National Electrical Manufacturers Association

May 5, 2023

RE: Request for Information: Innovative Advanced Transformers | DE-FOA-0003021

Re: Energy Conservation Program: Energy Conservation Standards for Distribution Transformers, docket
EERE-2019-BT-STD-0018

Figure 1: Trip curves with low-voltage distribution transformer inrush, Schneider Electric.

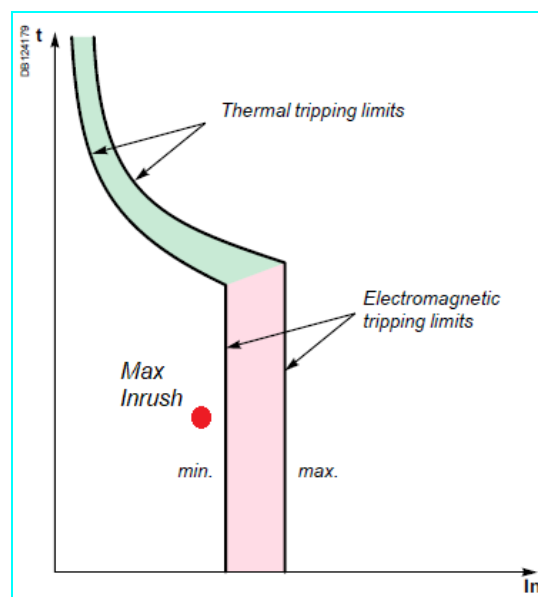
20) DOE requests comment on the interaction of inrush current and data center distribution transformer design. Specifically, DOE seeks information regarding: (1) the range of inrush current limit values in use in data center distribution transformers; (2) any challenges in meeting such inrush current limit values when using amorphous electrical steel in the core; (3) whether using amorphous electrical steel inherently increases inrush current, and why; (4) how the (magnetic) remanence of grain-oriented electrical steel compares to that of amorphous steel; and (5) other strategies or technologies than distribution transformer design which could be used to limit inrush current and the respective costs of those measures.

These questions need to be addressed across all applications for LVDT products, not only data centers. Manufacturers of data center design transformers have these concerns due to challenges faced meeting current regulations, however these challenges will now be faced potentially in all applications that install LVDT units. Some applications will only see the issue during installation and power loss, but as alternate power systems increase in the market more LVDT units will have power transferred from one source to another. NEMA members are entering these comments with respect to all LVDT applications, inclusive of data center applications.

(1) Regarding the range of inrush current:

The maximum inrush must be designed to be on the left of the over current trip curve, allowing the device to continue to function even when seeing maximum inrush from the transformers.
